DEVELOPMENT ASSESSMENT REPORT	
<b>Application No.</b>	DA/2023/0651
<b>Address</b>	323 Darling Street BALMAIN
<b>Proposal</b>	Alterations and additions to existing building to provide a mixed use development comprising two retail tenancies and restaurant with outdoor dining at ground floor level and five residential apartments over, all over two levels of parking
<b>Date of Lodgement</b>	24 August 2023
<b>Applicant</b>	M and B Maxwell Property Group Pty Ltd
<b>Owner</b>	The Owner of Strata Plan No 31401
<b>Number of Submissions</b>	15 unique objections
<b>Value of works</b>	\$3,574,000.00
<b>Reason for determination at Planning Panel</b>	Section 4.6 variation exceeds 10% Number of submissions
<b>Main Issues</b>	Streetscape; Non-compliance with FSR; non-compliance with SEPP (Housing); SEPP (Resilience and Hazards); amenity impacts to surrounding properties; car parking; waste management; stormwater
<b>Recommendation</b>	Refusal

Section 4.4 – Floor Space Ratio and Section 4.4A – Exception to Maximum Floor Space Ratio for Active Street Frontages

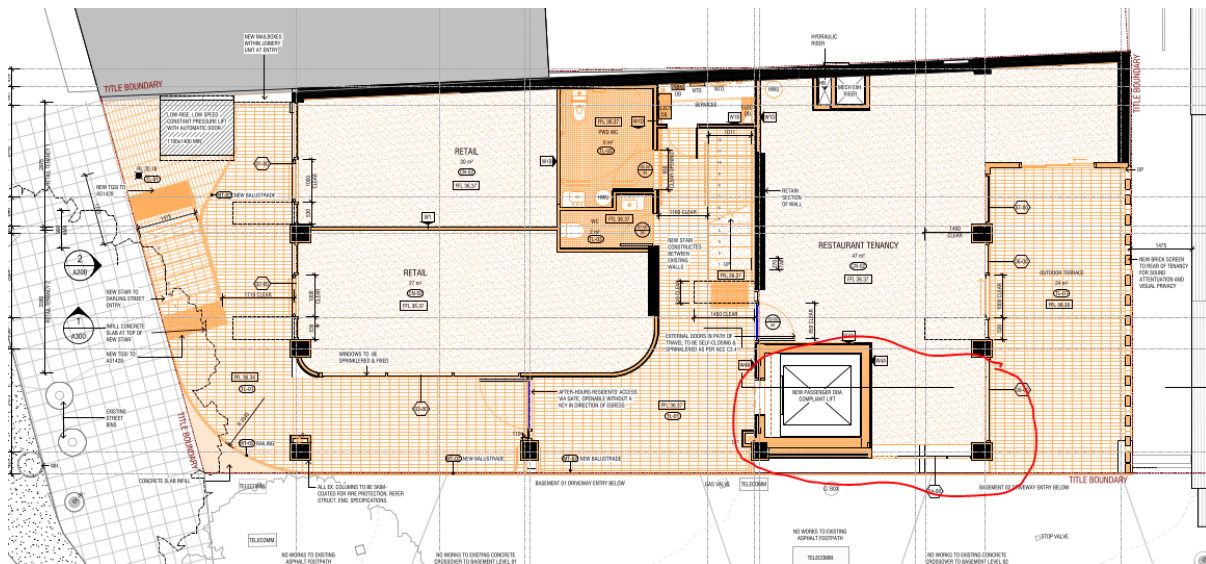
It should be further noted that, while there is some reduction of the total amount of Gross Floor Area as a result of voids created through the proposed lift shaft and removal of corridor areas, there are changes at the ground floor level which includes the provision of new gross floor area to the north of the proposed lift shaft, which was previously unenclosed, that is floor area associated with the proposed café/restaurant, so it cannot be considered as “keeping status-quo” with regard to gross floor area (see extract of proposed ground floor plan below, the red bubble indicated the area where the new gross floor area is proposed)
